**Visions In Education**  
**TENANT IMPROVEMENT PROJECT**  
**Project # 24-01**  
**ADDENDUM NO. 2**

May 15, 2024

A2.8

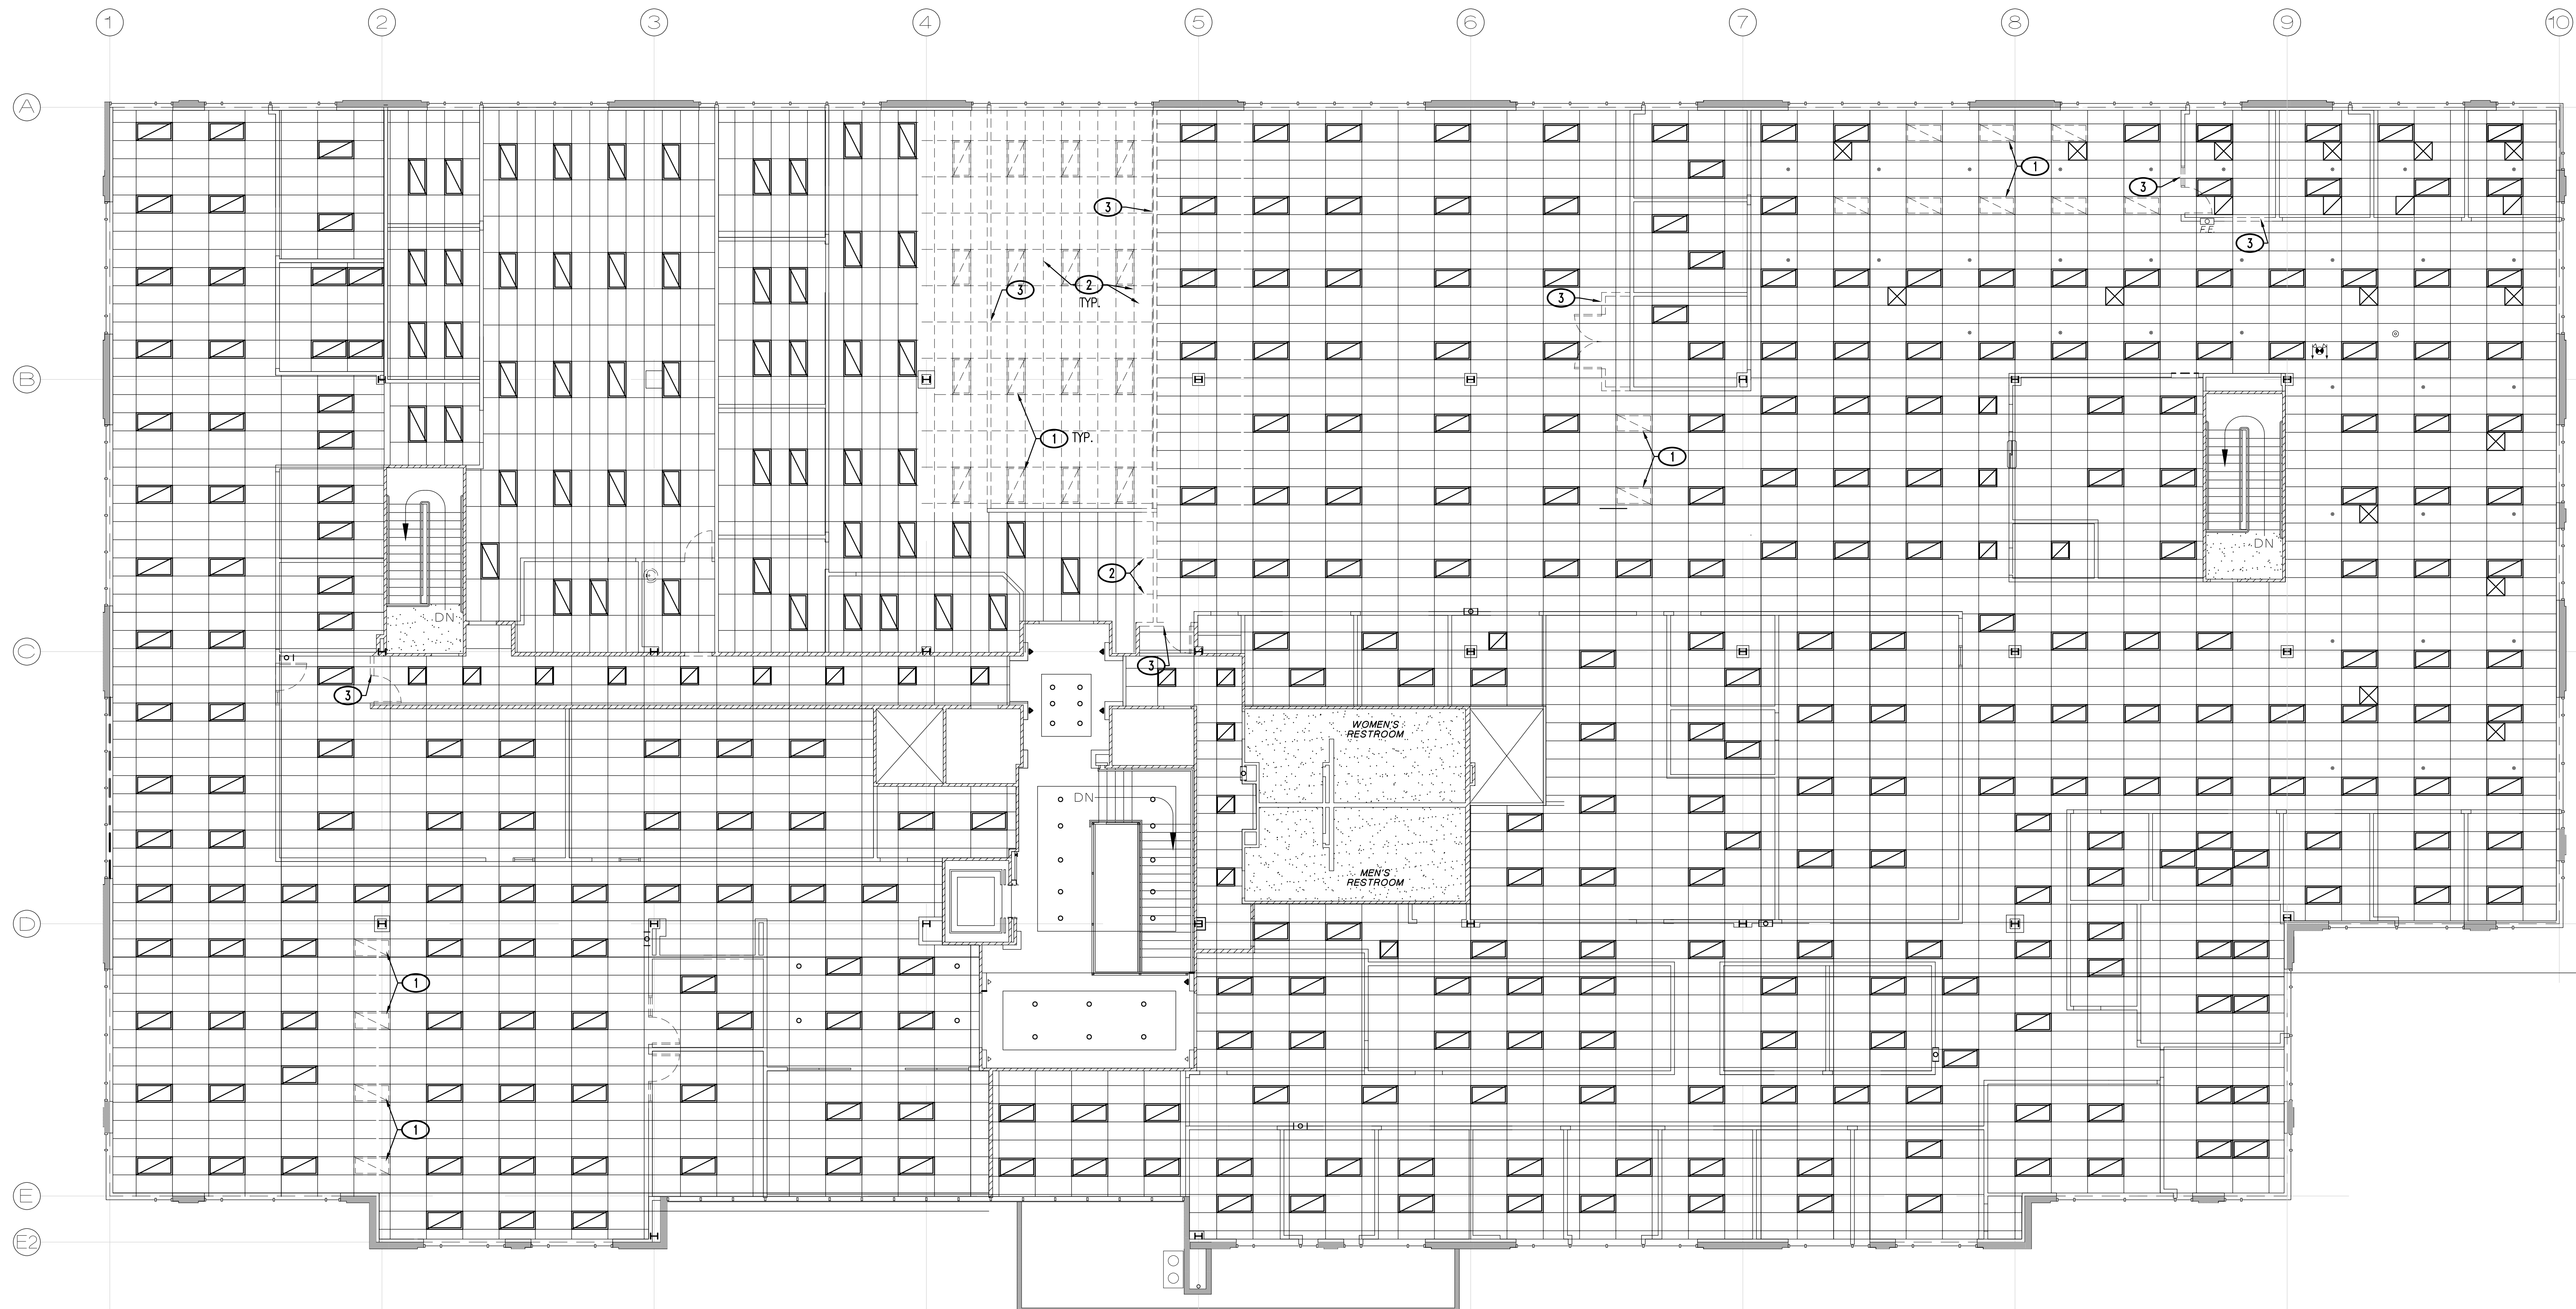
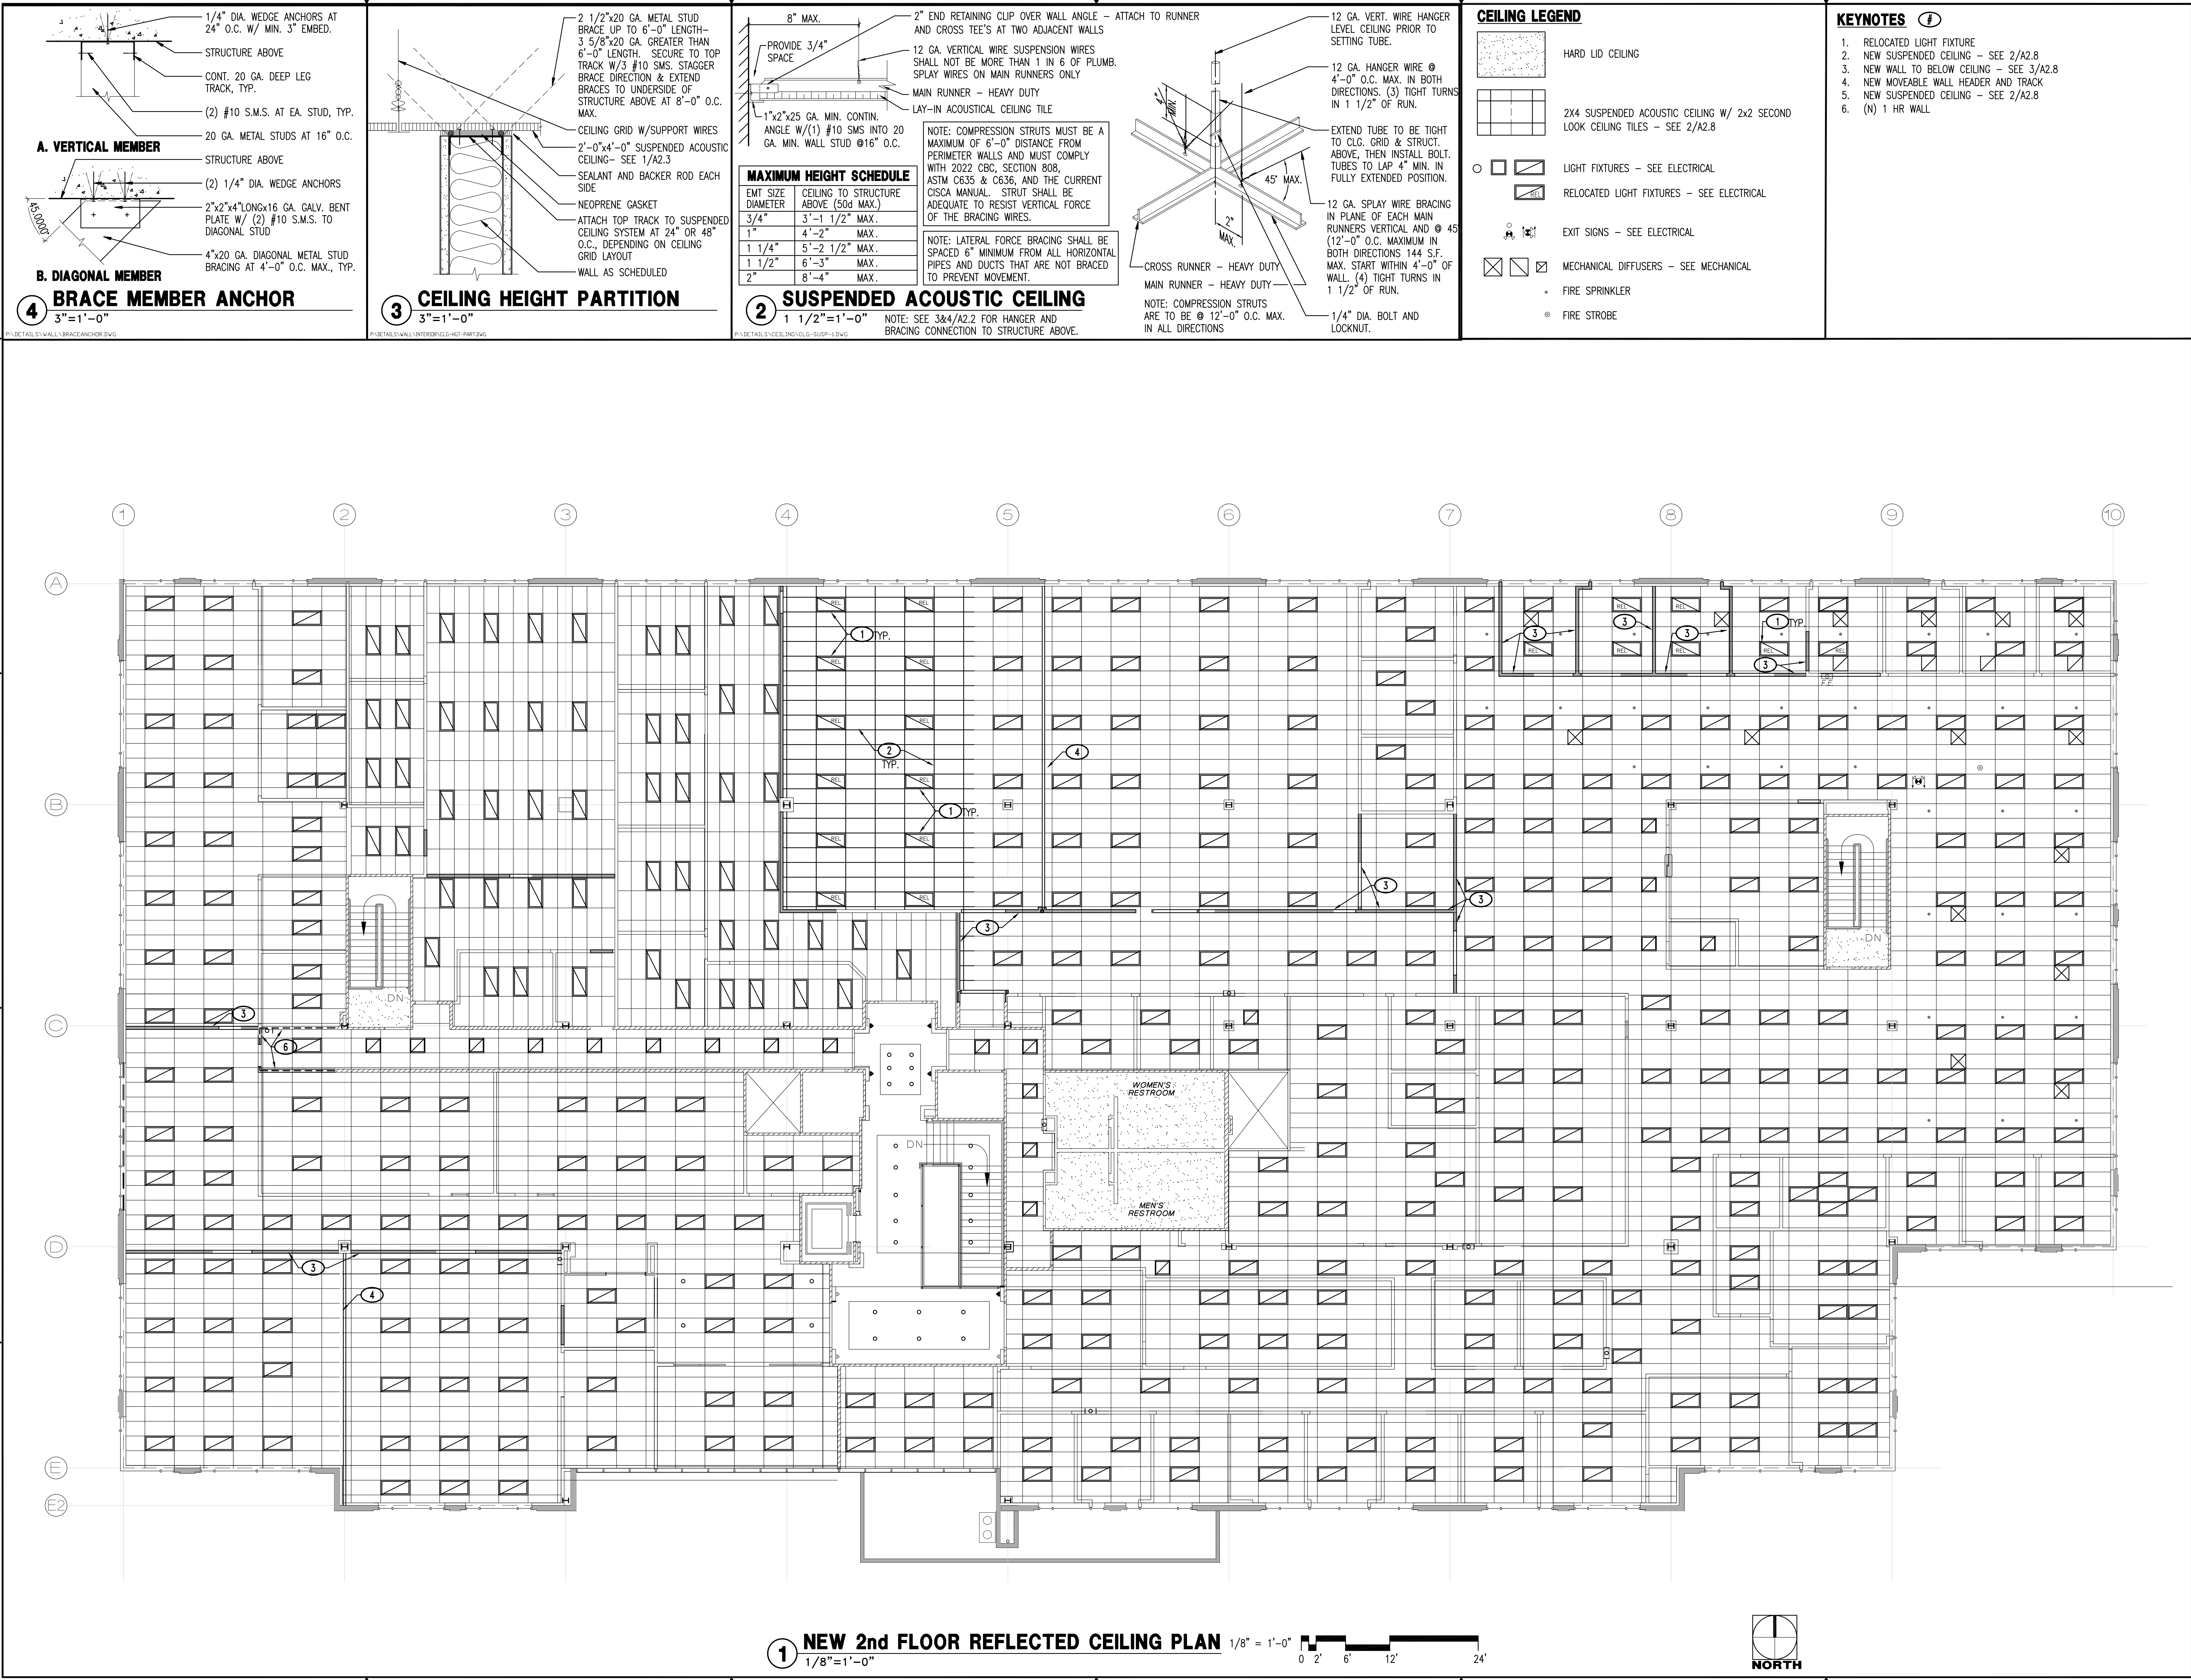
**QUESTION #32:** There are some discrepancies in the lighting plan. Please see the attached lighting layout markup. It appears that most of the light fixtures need to be relocated, removed or new. Can you please confirm this is the intent?

**Response:** Please refer to sheets A2.5 thru A2.8 in this addendum set. Scope for this project includes some relocation of lighting fixtures.
